Hi-Fi Products
Service Bulletin

Model: CDP-C315

No. 297

Subject: Chassis Replacement

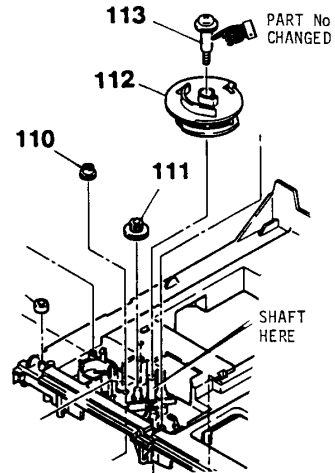
Chassis Replacement Part (Ref. 120, P/N 4-943-997-01) is different from original. The new replacement chassis has a shaft for mounting Cam Gear Ref. 112. When replacing the chassis, it is also necessary to replace the Hold Down Screw Ref. 113.

Solution: Order the Chassis and the Cam Gear Hold Down Screw as shown in the chart below:
